## **3.0 CORRECTIONS AND ADDITIONS TO THE DRAFT EIR**

## **5.F.4 ALTERNATIVE 4: MODIFIED DESIGN**

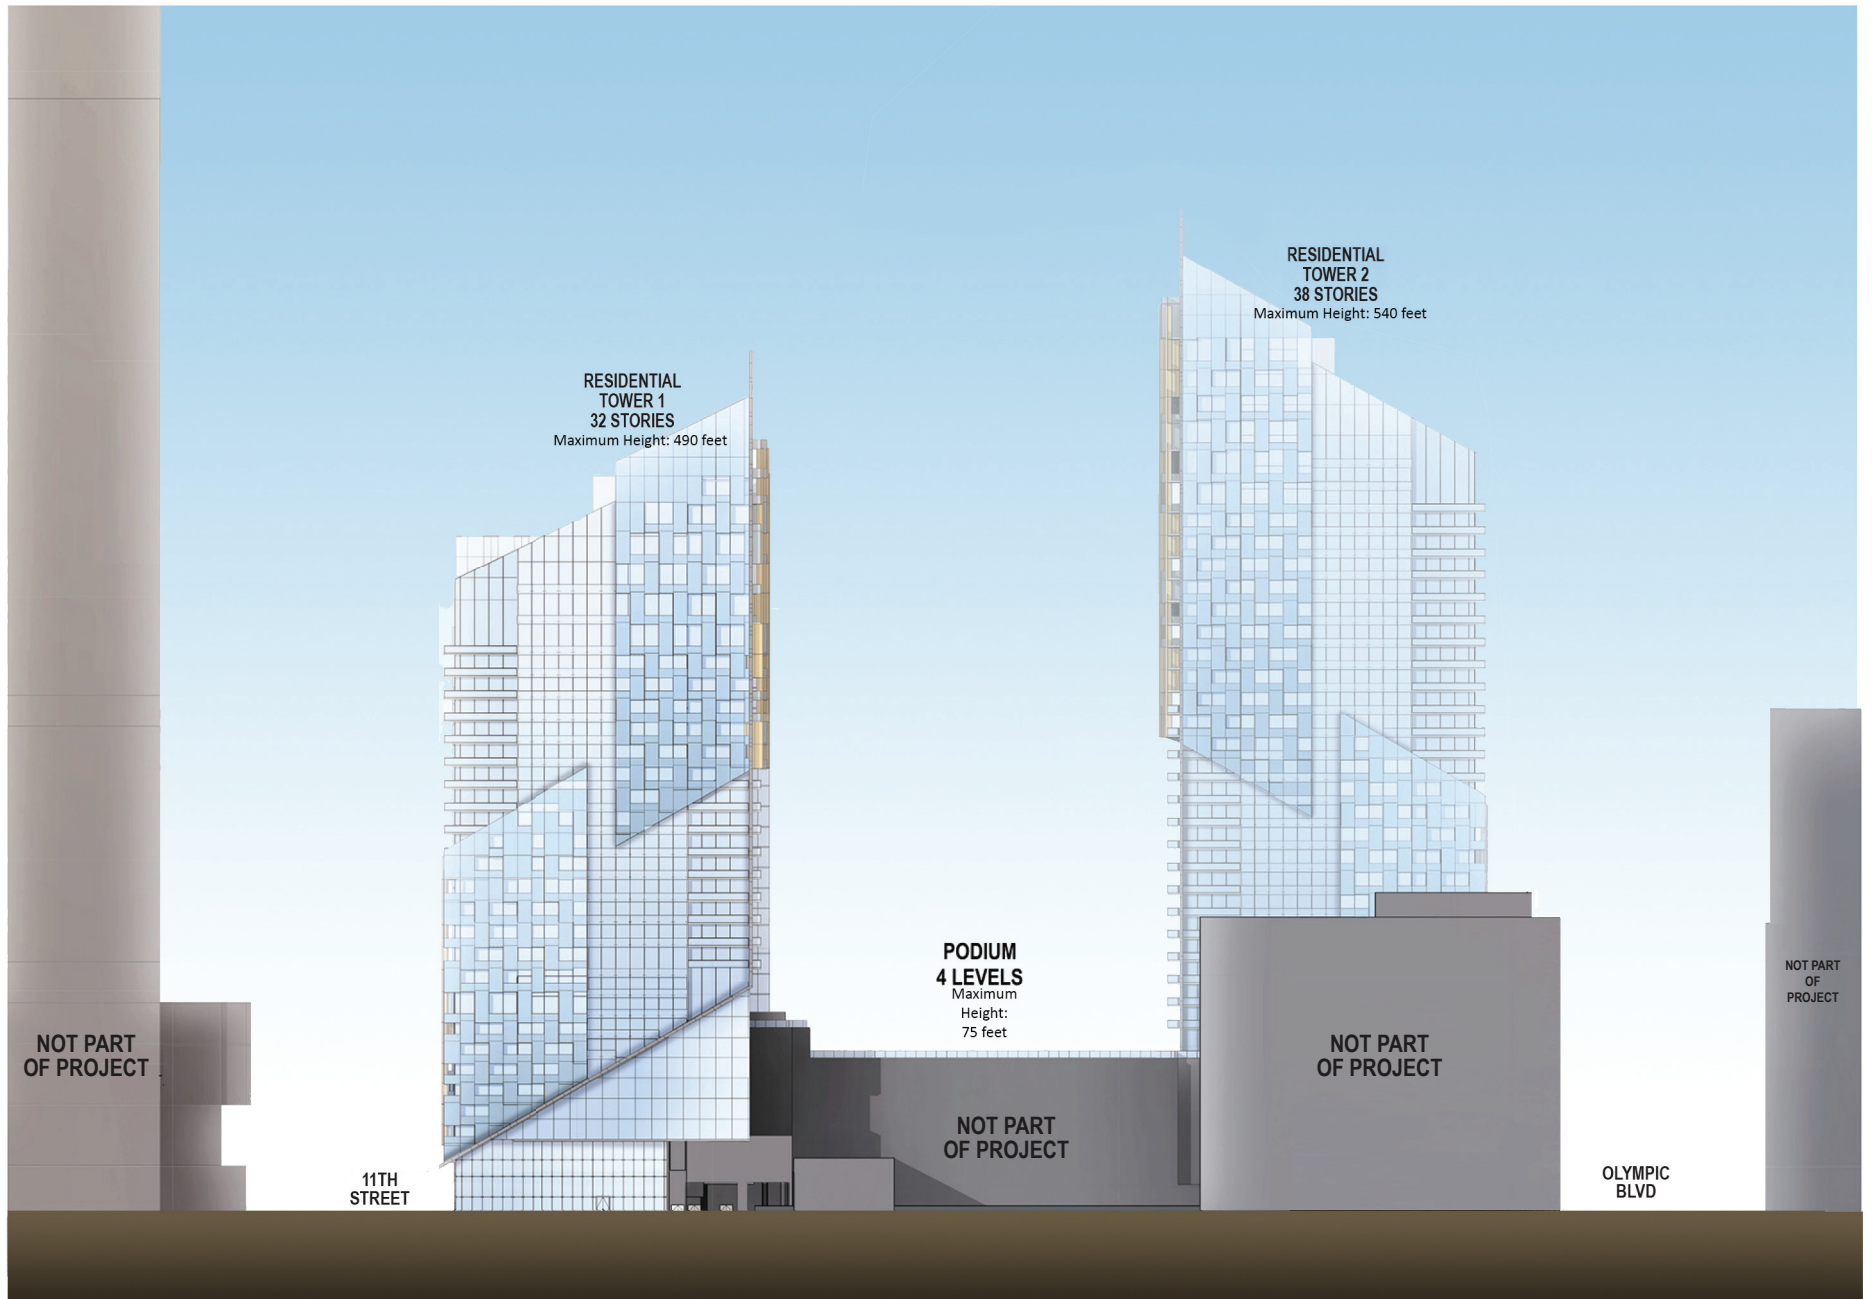
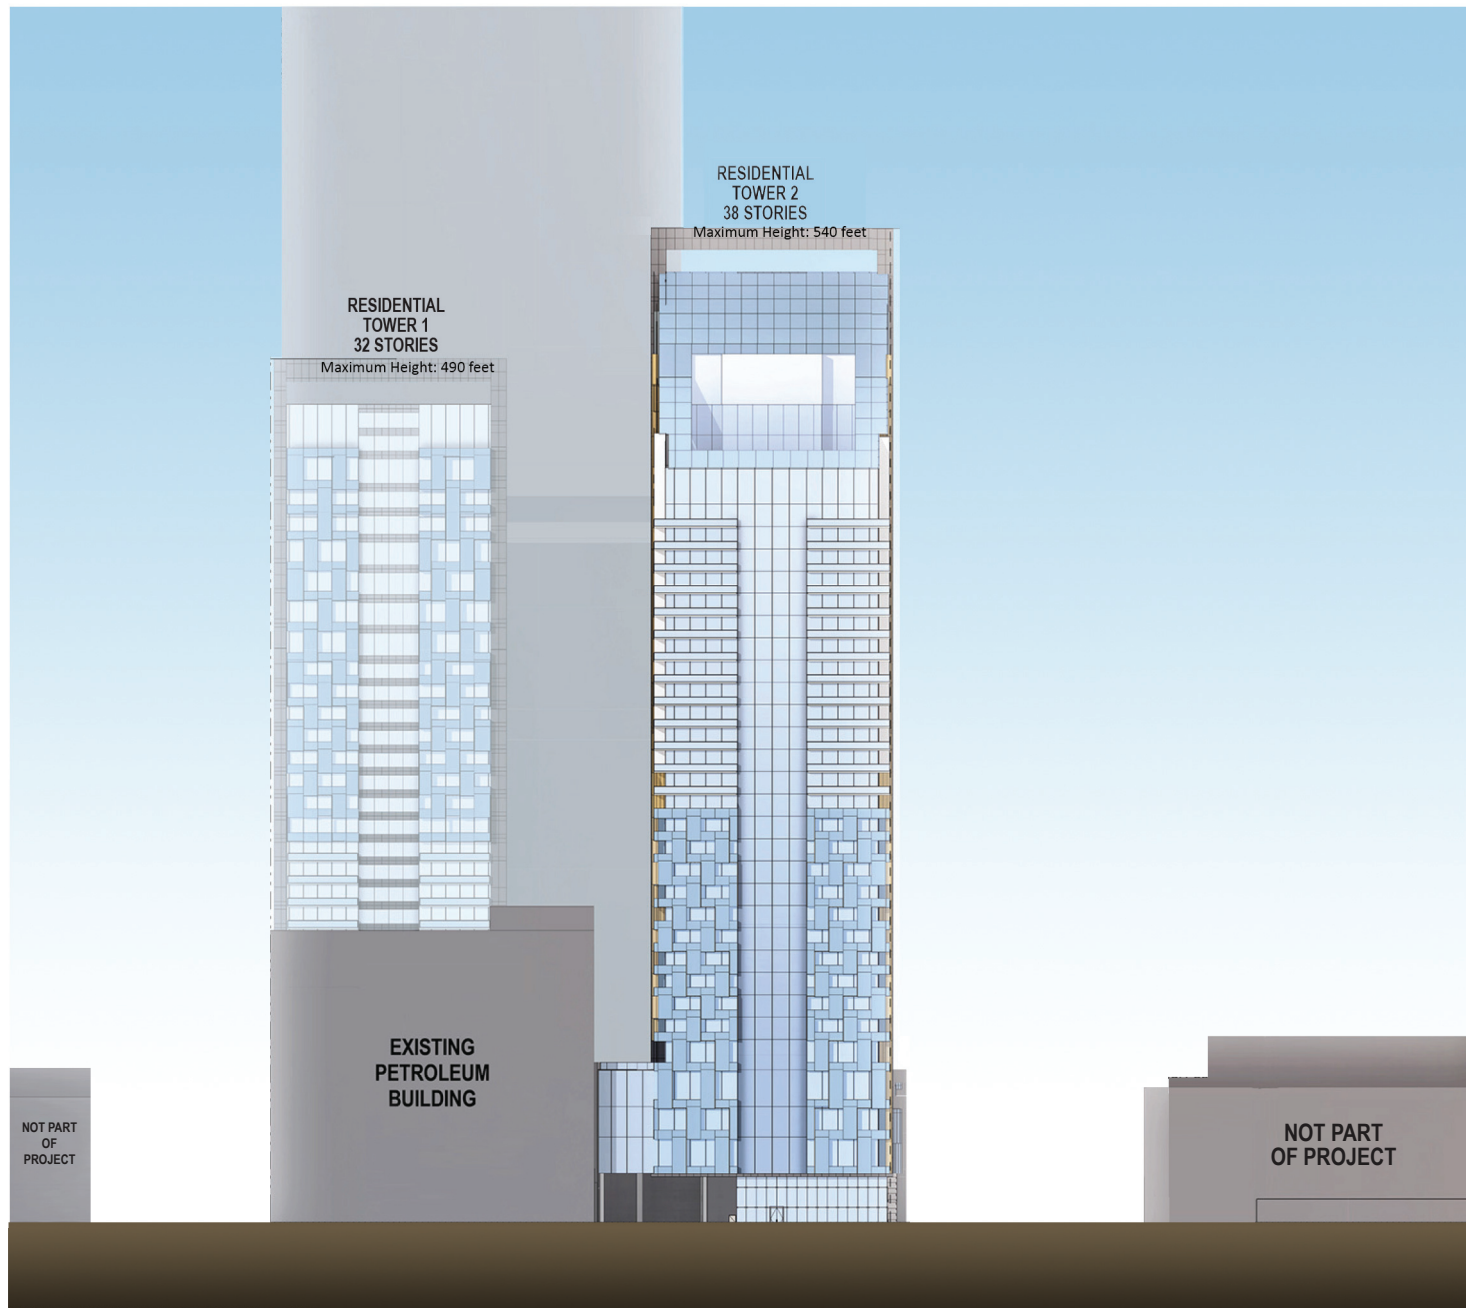
1. **Project Description, Pages 2-11, 2-17,2-18, 2-19, and 2-20. Modify Figures 2-3, 2-6, 2-7, 2-8, and 2-9 with the following changes.**

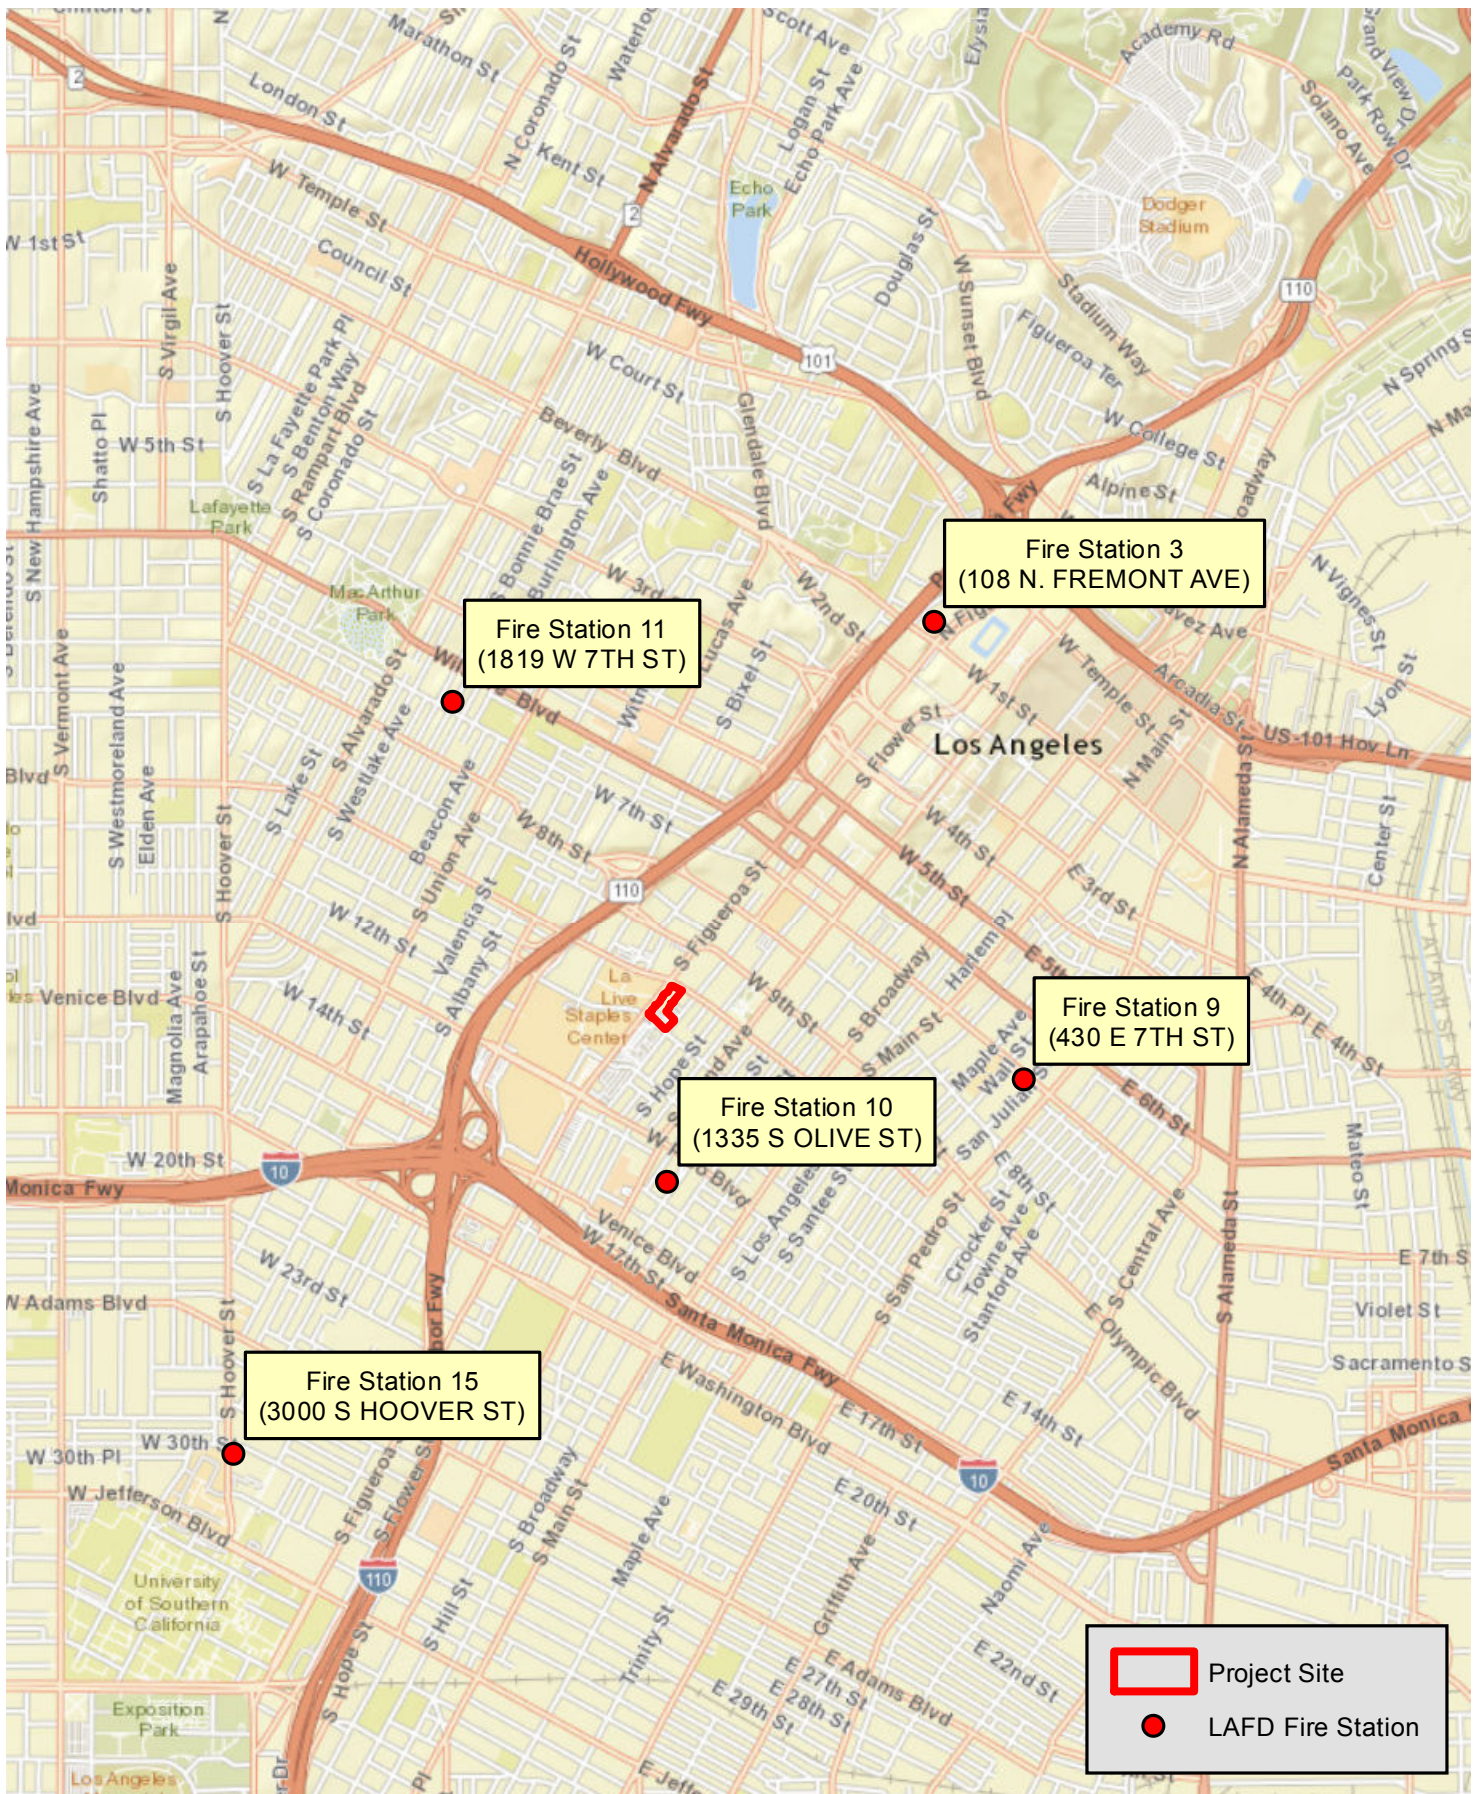
**3. Page 4.I.1-3, Modify Figure 4.I.1-1 with the following changes.**
